## PRODUCT / PROCESS CHANGE INFORMATION

1.1 Company		STMicroelectronics International N.V
1.2 PCI No.		CRP/21/12730
1.3 Title of PCI		CHANGE OF SUPPLIER FOR 3CP40619 (CARRIER TAPE Wi 16mm QFN/LGA 7x7x1.1 dsp)
1.4 Product Category		Refer to impacted product list
1.5 Issue date		2021-11-17

### PCI - CHANGE OF SUPPLIER FOR 3CP40619 (CARRIER TAPE Wi 16mm QFN/LGA 7x7x1.1 dsp)

#### NEW: ADVANTEK

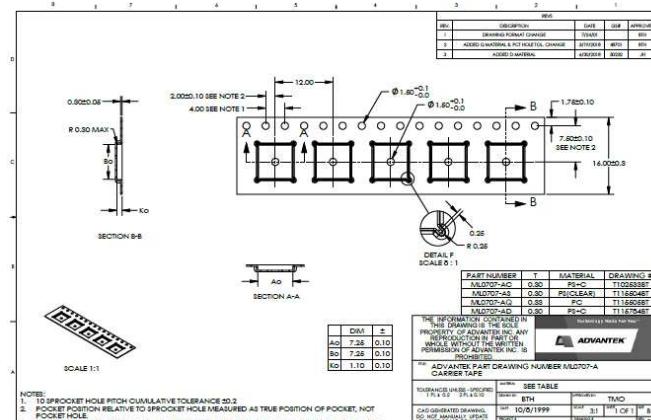
Change of supplier for ST material code reference: 3CP40619 (CARRIER TAPE Wi 16mm QFN/LGA 7x7x1.1 dsp) from PEAK to ADVANTEK. This change affected ST CALAMBA.

# Visual Inspection Report

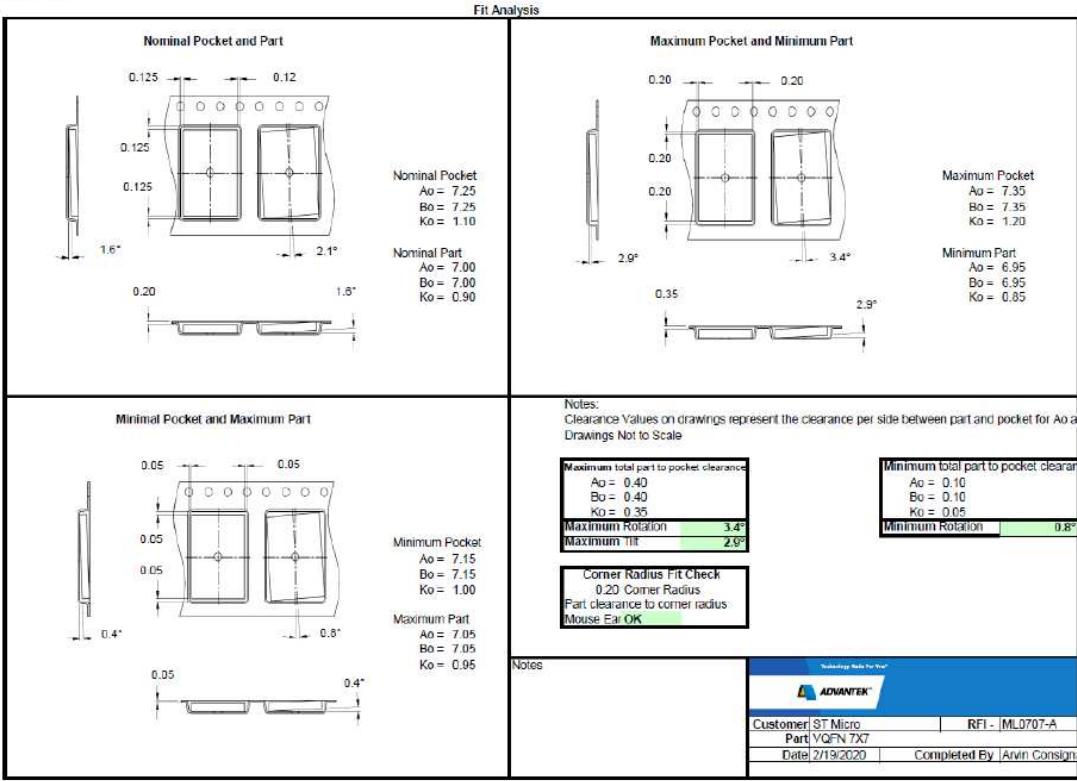
Visual inspection	Results
Does not contain stain or foreign material	Passed
No Damage	Passed
No Burr	Passed
Orientation	Passed
The component does not protrude above the top surface of the carrier tape	Passed
The component can be removed from the cavity in a vertical direction without mechanical restriction, after the top cover tape has been removed.	Passed
Lateral movement of the component is restricted to 1.0mm maximum	Passed
